SUBJECT: DIABLO CANYON POWER PLANT, UNIT NO. 1 AND UNIT NO. 2 –
ISSUANCE OF AMENDMENT – REVISION OF TECHNICAL SPECIFICATION
(TS) TABLE 3.3.1-1, "REACTOR TRIP SYSTEM INSTRUMENTATION," AND
REVISED REACTOR COOLANT SYSTEM FLOW MEASUREMENT (TAC NOS.
MB6760 AND MB6761)

PACIFIC GAS AND ELECTRIC COMPANY
DIABLO CANYON NUCLEAR POWER PLANT, UNIT NO. 1
DOCKET NO. 50-275
AMENDMENT TO FACILITY OPERATING LICENSE

PACIFIC GAS AND ELECTRIC COMPANY
DIABLO CANYON NUCLEAR POWER PLANT, UNIT NO. 2
DOCKET NO. 50-323
AMENDMENT TO FACILITY OPERATING LICENSE

SAFETY EVALUATION BY THE OFFICE OF NUCLEAR REACTOR REGULATION
RELATED TO AMENDMENT NO. 161 TO FACILITY OPERATING LICENSE NO. DPR-80
AND AMENDMENT NO. 162 TO FACILITY OPERATING LICENSE NO. DPR-82
PACIFIC GAS AND ELECTRIC COMPANY
DIABLO CANYON POWER PLANT, UNITS 1 AND 2
DOCKET NOS. 50-275 AND 50-323

Figure 5

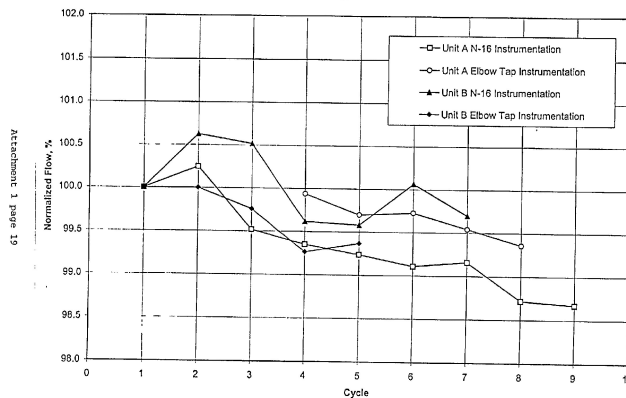
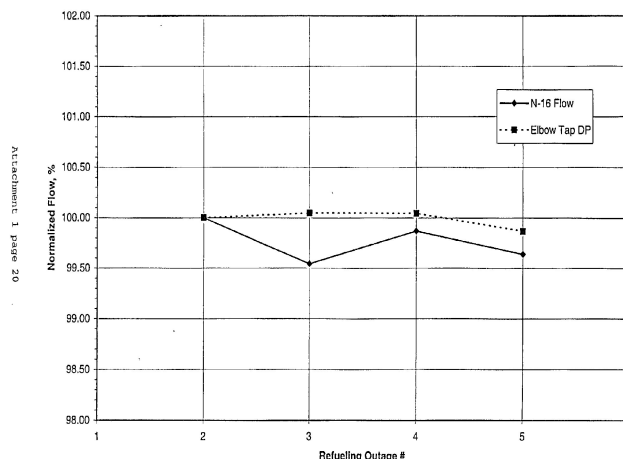
The staff obtained additional information during another review that is applicable to the topic of long-term elbow tap stability. Reference 7 discusses data obtained from three other plants equipped with N-16-based RCS loop flow rate instrumentation. In each case, usage was stated to be limited to the start of each cycle with the purpose of normalizing the main control board RCS flow rate indications. The reproduced Figure 5, to the right, provides normalized flow rate versus cycle data for two plants identified as Units A and B. The Unit A data for Cycles 4 through 8 show similar downward flow rate trends for the N-16 and elbow tap instrument data with a relatively consistent offset ranging from 0.4 percent to 0.7 percent. The Unit B data for Cycles 1 through 5 show somewhat more variation, with the N-16 and elbow tap data becoming closer together with increasing cycles. The N-16 fluctuations were attributed to the uncertainty band in the instrumentation, but substantiation for this conclusion was not provided other than to note the flow rate increases at Cycles 2 and 6 could not be attributed to real flow increases and therefore could be attributed to measurement process variation. Examination shows that the elbow tap indications appear to be more stable. Overall, there is no indication of a long-term change in the elbow tap indications in comparison to the N-16 indications and the limited data for Unit A generally substantiate that the elbow tap flow coefficients remain constant.

The reproduced Figure 6, to the right, provides a similar comparison of N-16 and elbow tap flow rates for a third plant. Again, the elbow tap data appear somewhat more stable than the N-16 indications, but overall there is little variation.

There is no evidence of a long-term change in the elbow tap indications in comparison to the N-16 indications and the data generally substantiate that the elbow tap flow coefficients remain constant with increasing time.

Based on the above evaluation, the staff finds that the elbow tap flow meter coefficients remain sufficiently constant that the relative changes of flow rate through the cold-leg elbows can be correlated with the relative changes in the elbow tap ΔP s.

FIGURE 1. RCS LOOP CONFIGURATION

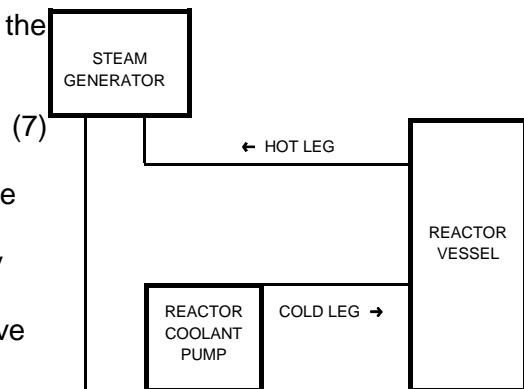
The RCS configuration illustrated in Figure 1 is used as a basis for flow rate analyses. An overall heat balance is taken over the control volume defined by the surface of the RCS to obtain Equation 7:

With Q_{core} determined, one may assume that mass flow rate through the core could be determined by dividing Q_{core} by the enthalpy difference across the core if the enthalpy difference were known. However, these enthalpies are not known because (1) core inlet temperatures are not measured, (2) there is a wide variation in core outlet temperatures with position across the top of the core, and (3) pressure variation within the RCS is not measured. (Enthalpy can be determined when temperature and pressure are known.) Consequently, it is necessary to make the determination where temperatures are measured that are representative of the bulk flowing

water. In practice, the hot and cold leg RTD temperatures, T_h and T_c respectively, are used. Pressure is determined by equating RCP head to the total pressure drop through the RCS for an assumed RCS flow rate and calculating the variation of pressure relative to a measured value in the pressurizer.⁷
